#### **CONTRACTOR REPORT ARLCD-CR-84020**

### GEMSS EXTENDED RANGE TRIPLINE SENSOR (ERTS) PRODUCT IMPROVEMENT PROGRAM (PIP)

Table 1. Drawing change summary

Figure 1. Changes to end view on drawing 9292982

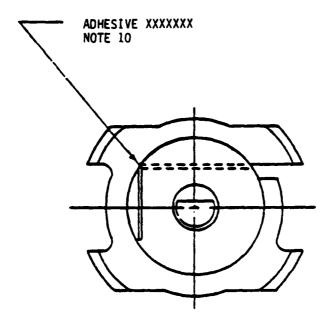
9298598 (Diaphragm)	In the table at the bottom of the drawing add "9292998" in the NEXT ASSEMBLY box for 9298598-1.	
9292982 (Bobbin Assembly)	In Note 2, "46 ± 3 FEET" should be "34 ± 2 FEET". In Note 7, "750 REVOLUTIONS" should be "580 REVOLUTIONS".  Delete Note 8. Change left view as shown in Figure 1. Add Note 10: "ADD A DROP OF ADHESIVE AT EXIT POINT OF THREAD JUST PRIOR TO ASSEMBLY OF THE BOBBIN WEIGHT INTO THE BOBBIN".	Permission to incorporate this change was granted by ARRADCOM approval of Deviation 0297-008 (Ref PAN A3N7705).
XXXXXXX (Adhesive)	Make a new drawing like Figure 2 for the adhesive.
